Serial ATA International Organization:

Serial ATA Revision ~~2.6~~3.0

~~15-February-2007~~
1-April-2009

Summary of Comments on IDLE

Figure 35 – Backplane connector interface dimensions

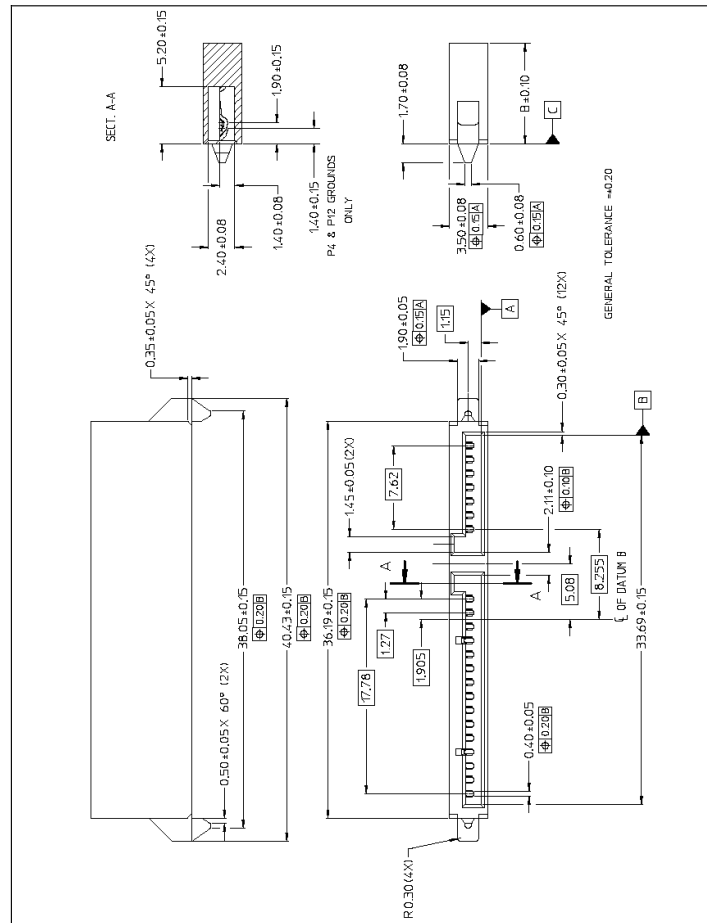
Author: paulw
Subject: Note
Date: 1/29/2009 4:49:12 PM
Regarding dimensions, in some places there is a space between the right-most digit and the units (8.15 mm), and in other places there's no space (14.15mm).

Author: STX-Hatfield
Subject: Note
Date: 2/3/2009 9:26:20 AM

Figure 7-3 – Analog Front End (AFE) Cabling
 [External AC Coupling Capacitors not shown]

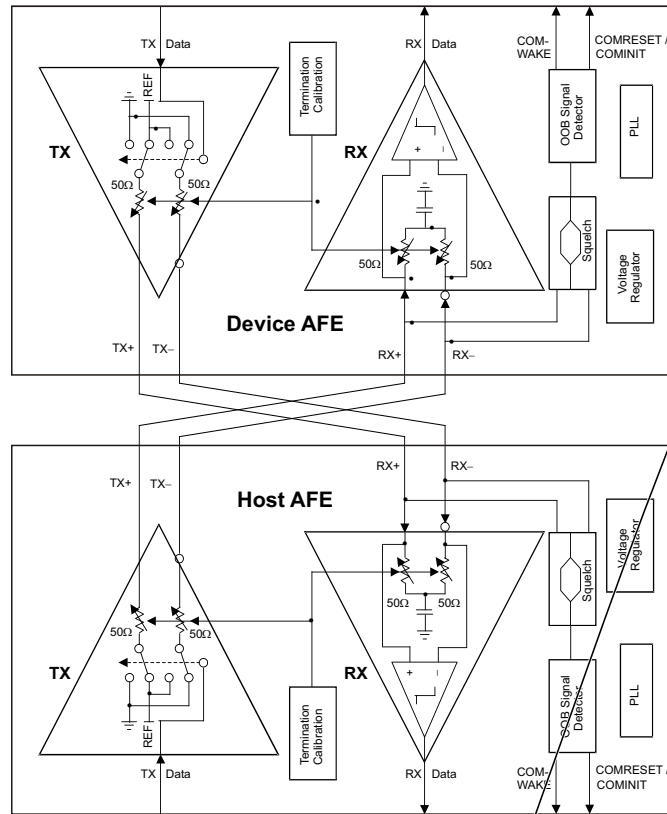
Author: STX-Hatfield
 Subject: Highlight
 Date: 2/8/2009 7:18:43 PM
 External AC Coupling Capacitors not shown
 Status
 STX-Hatfield Accepted 2/10/2009 11:32:15 AM
 Author: STX-Hatfield
 Subject: Note
 Date: 2/10/2009 11:32:11 AM
 leave it as is, without 'editors note'
